JOB NO: 5807

Location: Emsworth, Hampshire, PO10 7QH

Figure 3.4 – Vehicle Crossover Visibility

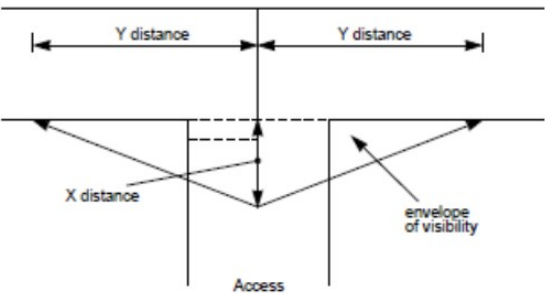
- Visibility splays to be provided in accordance with HCC TG3 with no obstructions within the splay.

As previously noted, this is effectively a reintroduction of access rather wholly new, however the visibility splay for vehicles leaving unit 8 is suitably in accordance with HCC TG3 figure 3.4 relating to vehicle crossovers with vehicles travelling at 20mph entering and leaving seagull lane. Even 20mph is probably a greater speed than most vehicles would ordinarily travel on this narrow access road.

Drawing Status		Final	
Client			
M&M Hall Family Pension Trust			
Project		Seagull Lane, Emsworth	
Drawing Title			
Unit 8			
Vehicle Swept Path Analysis			
Scale	Date	Drawn By	Checked By
1:250	Aug 22	SMO	EJD
Drawing No.			Rev.
2022-6442-006			A

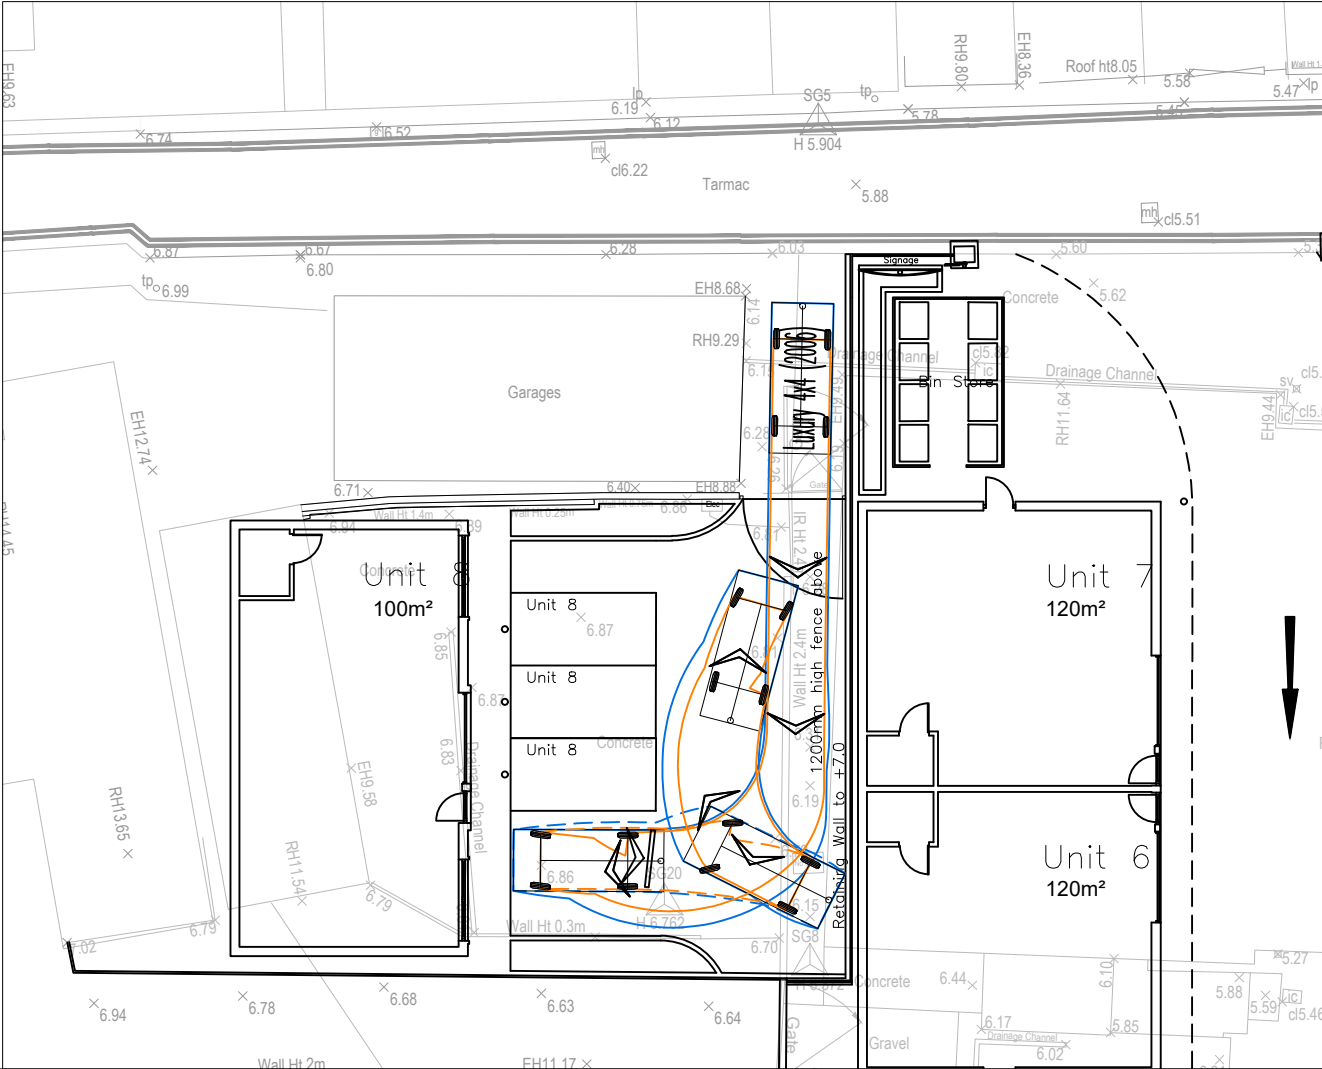
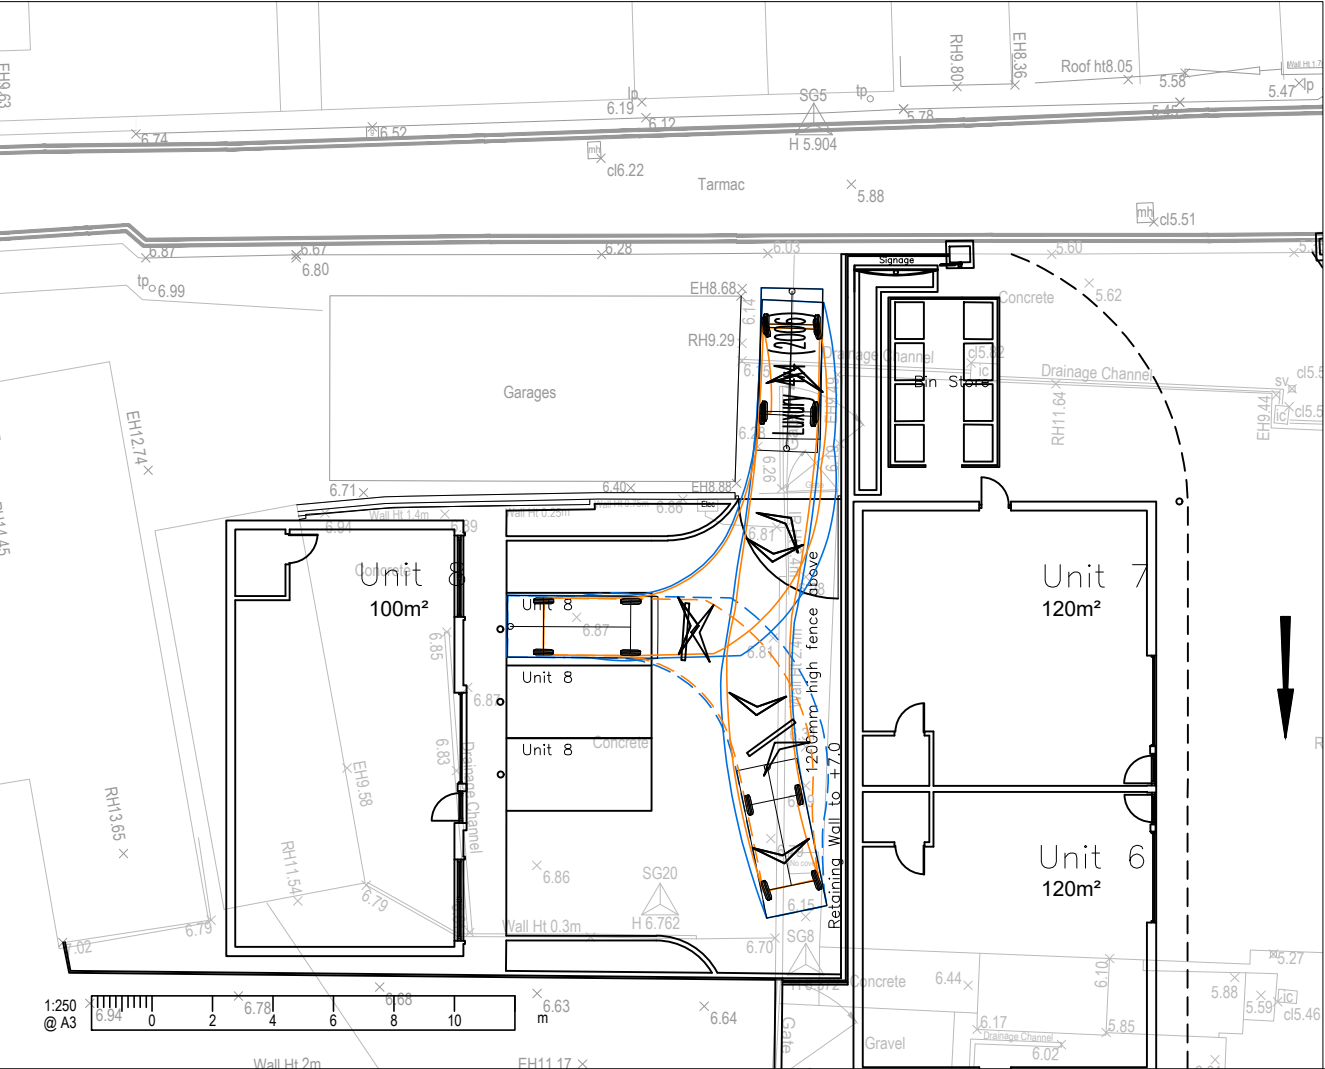
- Drawing 2022-6442-006 should be updated using the correct dimensions for a large family car.

Please find revised drawing 2022-6442-006A on page 5 of this response. This includes a revised parking layout for unit 8 for 3 bays in accordance with HBC parking standards.

Drawing Status		Final	
Client M&M Hall Family Pension Trust			
Project Seagull Lane, Emsworth			
Drawing Title Car Parking Vehicle Swept Path Analysis			
Scale 1:250	Date Aug 22	Drawn By SMO	Checked By EJD
Drawing No. 2022-6442-007			Rev. A

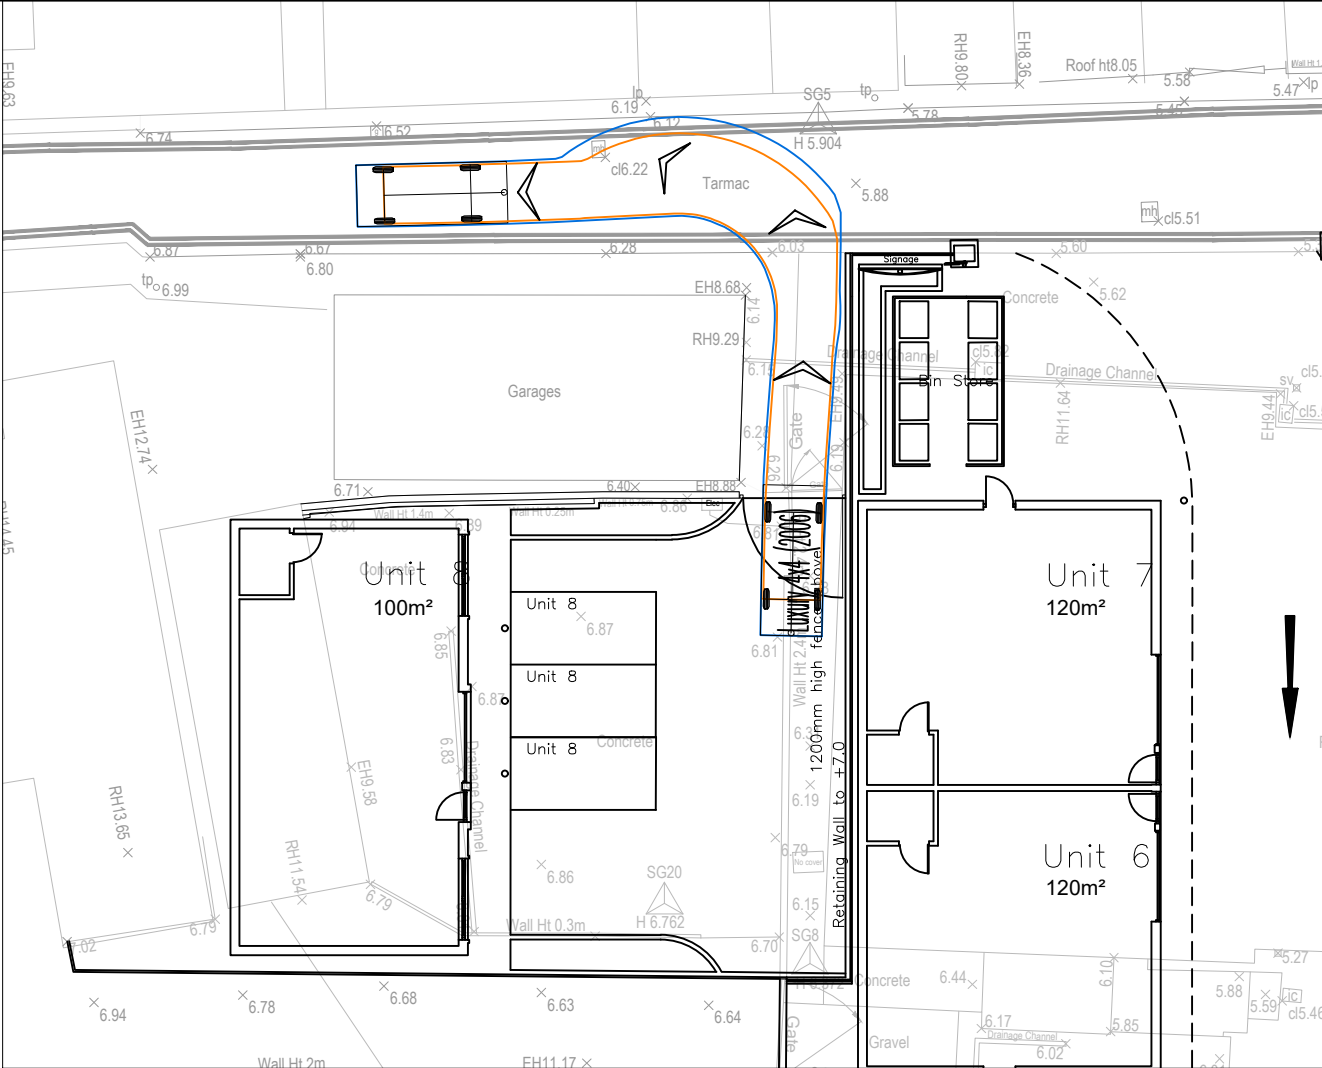
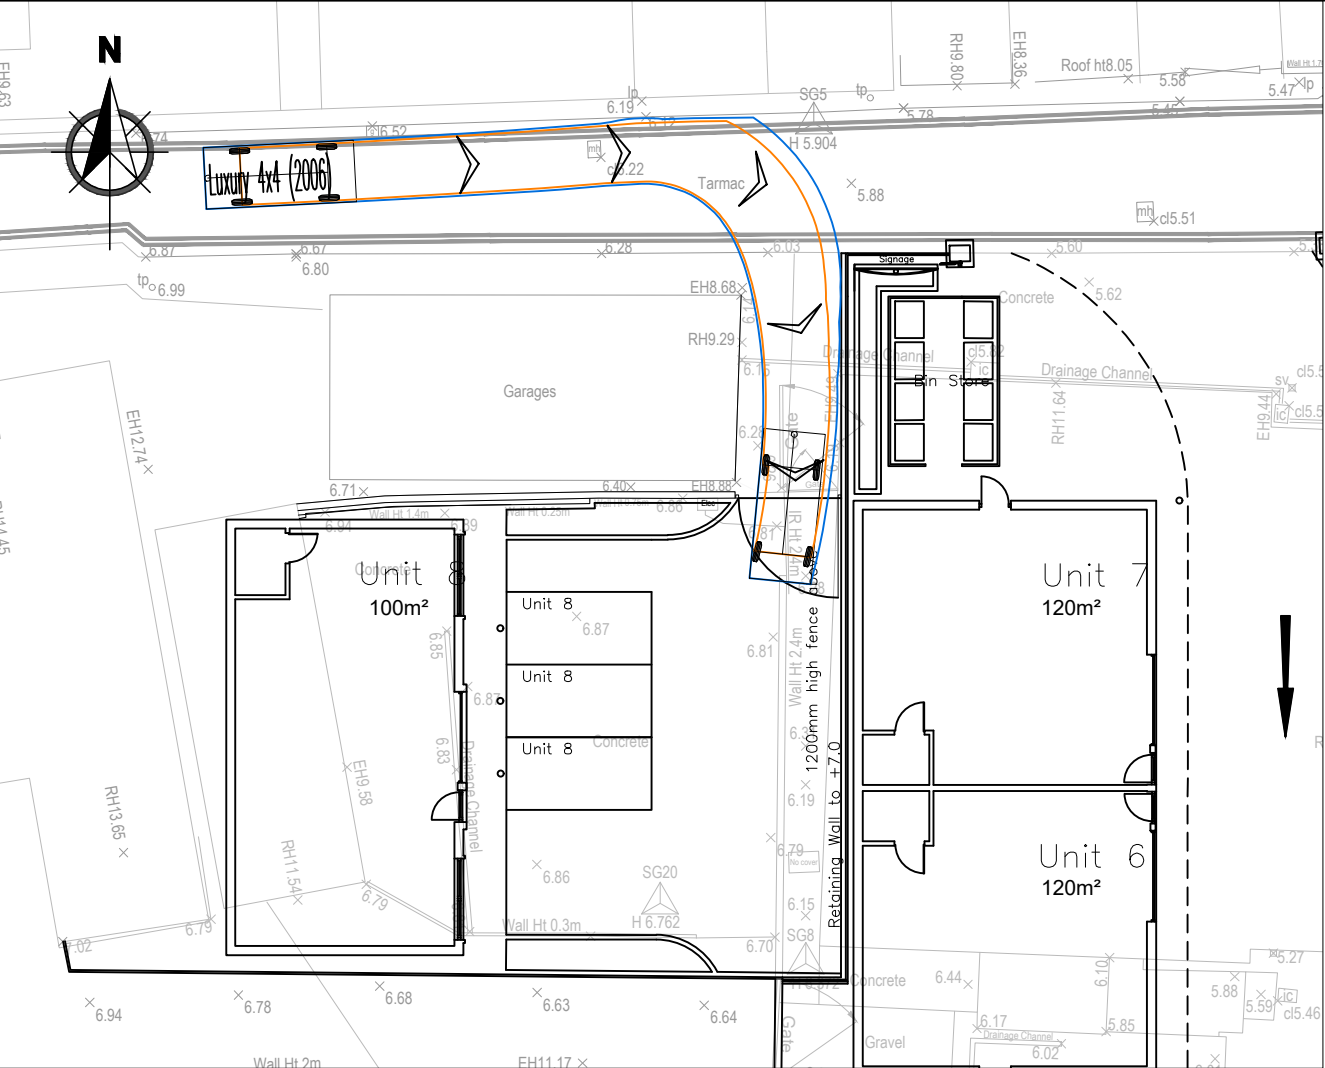
- Drawing 2022-6442-007 should also be revised using the correct dimensions for a large family car;

Please find revised drawing 2022-6442-007A on page 6 of this response. This includes a revised parking layout for unit 8 for 3 bays in accordance with HBC parking standards.
